**RECORD OF DECISION AMENDMENT
ALLIED CHEMICAL/IRONTON COKE SUPERFUND SITE
IRONTON, OHIO**

RECORD OF DECISION AMENDMENT

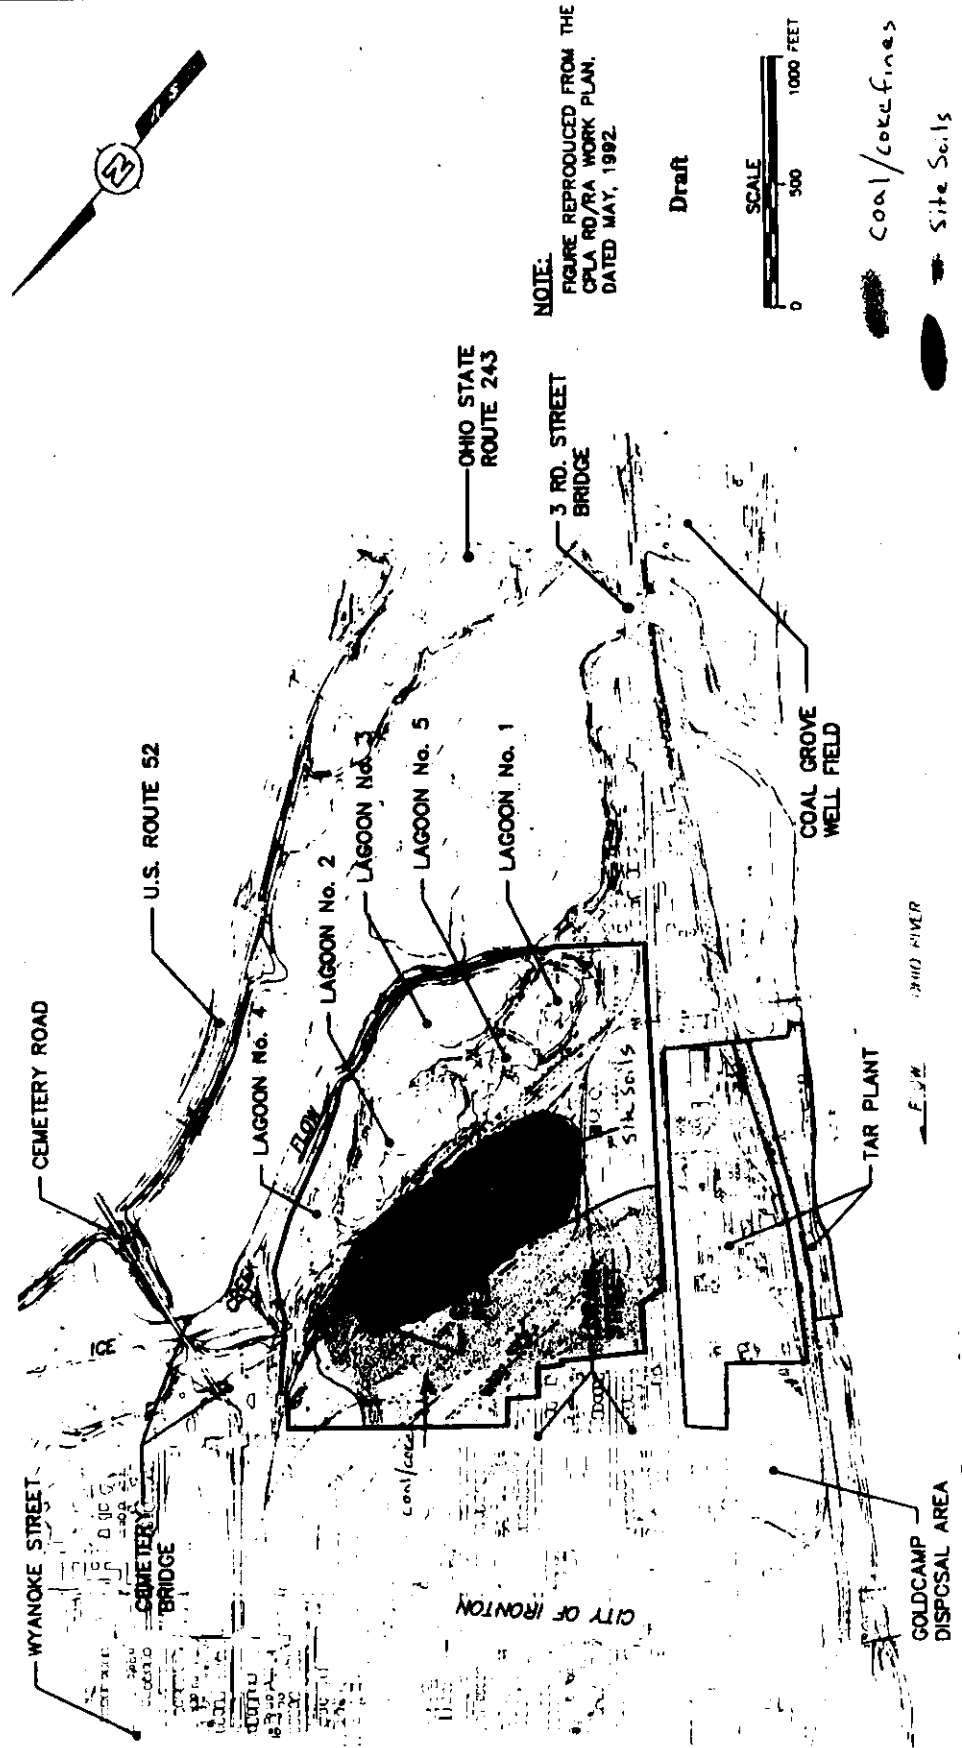
During the design phase for the CPLA, approximately 135,000 cubic yards of soil located near the former coke plant and contaminated with PAH_c above the 0.97 ppm cleanup standard were recently identified. The newly discovered contaminated soils, identified as the "site soils," are estimated to have an average PAH_c concentration of 20 ppm. The site map in Figure 1 outlines the general area of the "site soils". Table 1 lists the soil cleanup standards for the CPLA.

A discussion on the comparison of the four alternatives to address the newly discovered "site soils" is discussed below. The best balance of the nine criteria is implementing Alternative 1, which is excavate and store the "site soils" on the AlliedSignal property for eventual treatment or placement into the lagoon area.
